Appendix E. Design Event Modelling Input Data and Model Peer Review

Project Name	Lower Macleay Flood Study
Model Reviewed	LM_20m_Hist_2001_Shift_Q_plus2p5hr_039 (2001 Calibration)
Report Reviewed	Model Development and Calibration Report (Revision A)
Date of Review	09/11/2018
Reviewer	Shilin Chen, Greg Rogencamp

1. Summary

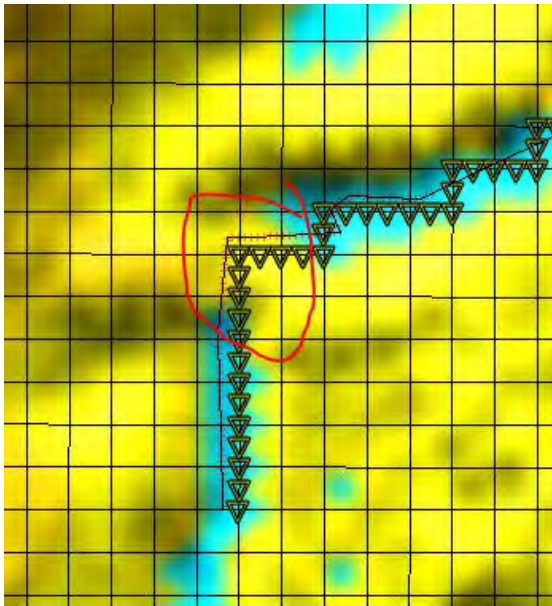
The input geometry data were taken from the 2009/2010 1m, 2016 5m and 2009/2010 10m LiDAR data which would give a reasonable representation. Where available, bathymetric data was obtained and used to represent channel beds in the TUFLOW model. The vertical accuracy of the terrain sources should be documented in the report.

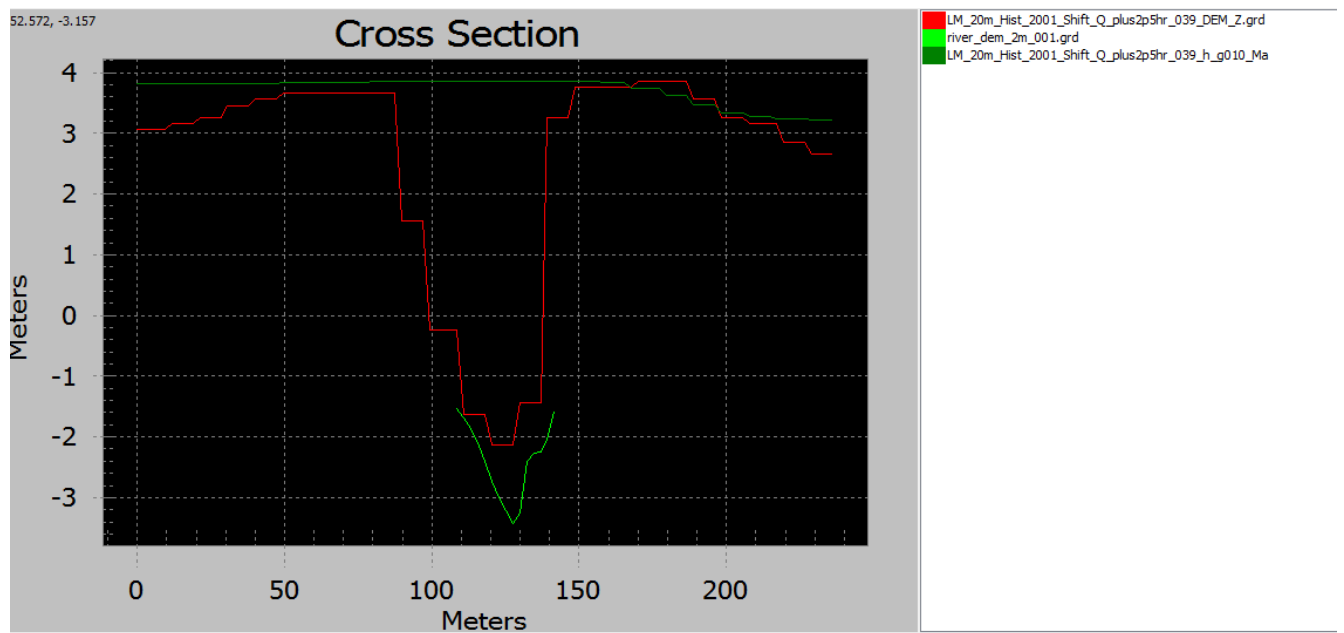
At the Collombatti Creek catchment, the 'gully line' to represent the low-flow part of the channel has not been correctly read as it has not been set as a MIN or GULLY line. This has created an artificial wall, which is blocking the waterway (see image below). **The river line needs to be read in correctly.**
